5 August 2014

**Amendment Modification 2 (MOD 2)  
Relating to Trinity Point Marina & Mixed Use Development  
(MP 06\_0309)**

This correspondence provides an amendment to Modification 2 for assessment and determination.

**FIGURE 1 – CONCEPT MARINA LAYOUTS**

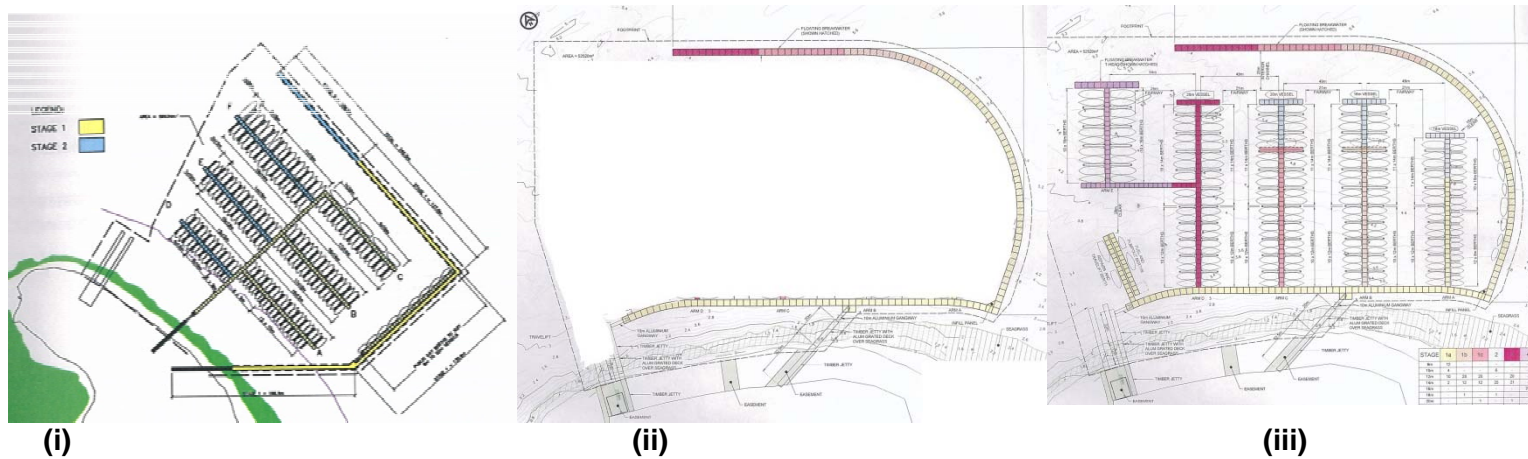
Figure 1 provides images of (i) the 188 berth concept marina layout was provided with Preferred Project Report with the concept approval, (ii) the modified 188 berth concept marina layout incorporated into the approval by virtue of Condition B1 (with internal layout and staging excluded) and (iii) the modified 188 berth concept marina layout included with Condition B1 documentation (showing indicative internal layout and staging). Figure 2 includes a comparison image comparing these.

- The Concept Marina Layout included in this Modification 2 update proposes a minor change (15m) in the location of the floating breakwater footprint and its extent into Bardens Bay compared with Condition B1 determination, as illustrated in Figure 3 overpage (note the distances shown are to the proposed outer breakwater edge). The minor 15m change is associated with further development of the floating breakwater details and internal marina layout. It still represents a reduction in the footprint extending into the Bay from the original layout. The minor change has negligible implications on the parameters which guide Condition B1. Minimising distance into the Bay was identified in past DG assessments of the concept plan as a desired outcome to primarily minimise visual impact to properties to the north along Pillapai Road (based on the extent to which the marina extends into their view of the bay and
